2000 Corvette: Service Bulletin: Low Tire Pressure Message on DIC, Slow Air Loss

Number: 00-03-10-001

Subject: Low Tire Pressure Message Repeatedly Displayed on DIC, Slow Air Loss From Tire and Wheel Assembly (Replace Wheel Assembly)

Model Year: 2000 Chevrolet Corvette Built prior to VIN Breakpoint Y5001500

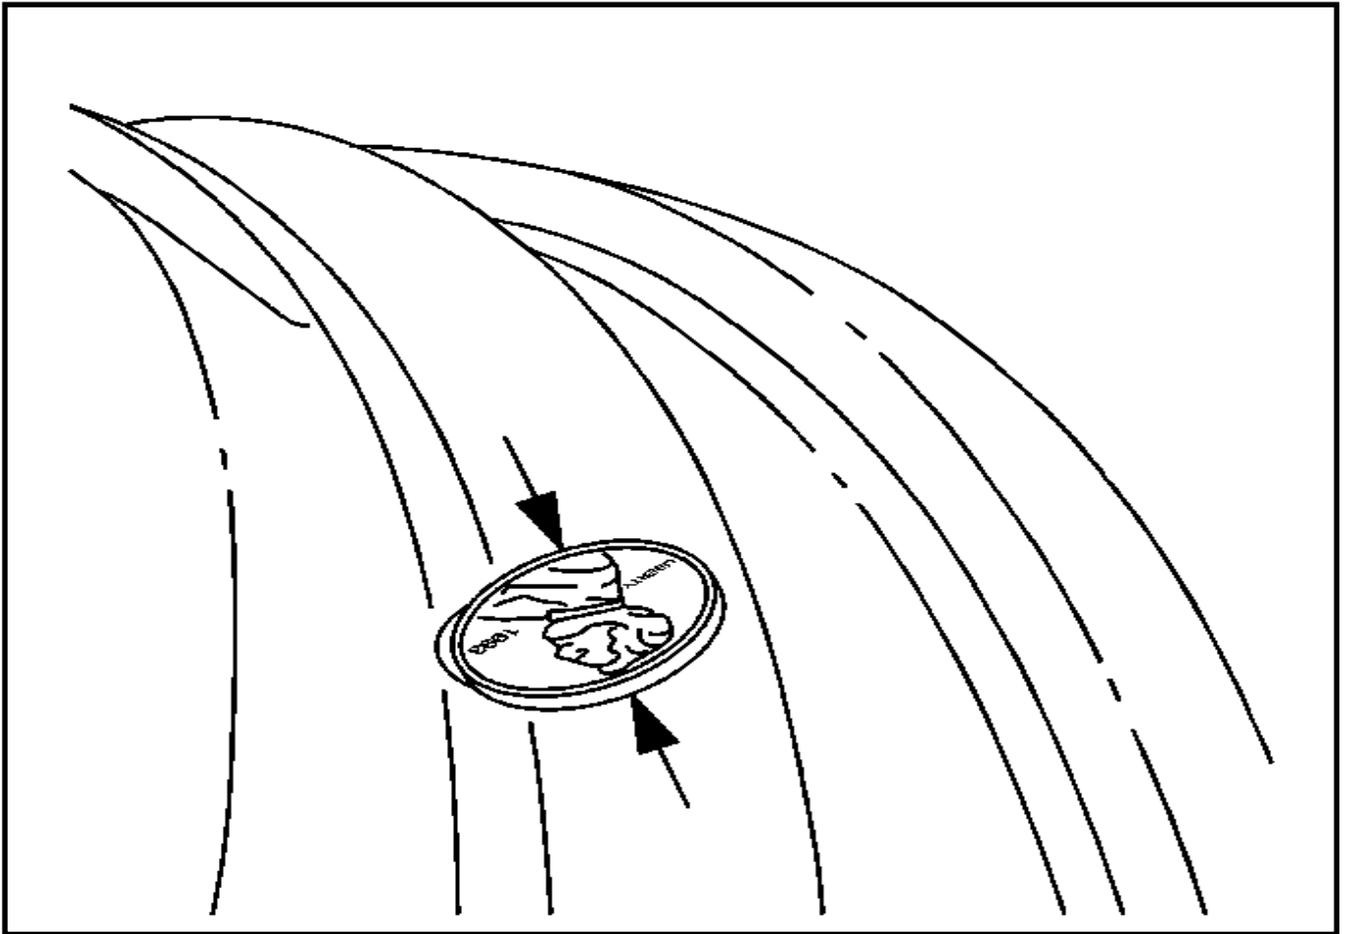
Wheels that exhibit a repeat leak down condition may have been machined in such a manner that the valve stem/tire pressure sensor counterbore is too deep, resulting in air leakage past the sensor's seal.

With the tire and valve stem/tire pressure monitor removed from the suspect wheel, place a penny in the counterbore where the valve stem/tire pressure monitor seats on the inside of the wheel. If the penny sits in the counterbore so that it is below the unmachined surface of the wheel at the points indicated by the arrows in the illustration (counterbore depth more than 1.1 mm (.043 in), replace the wheel assembly with the appropriate service part indicated in the chart below.
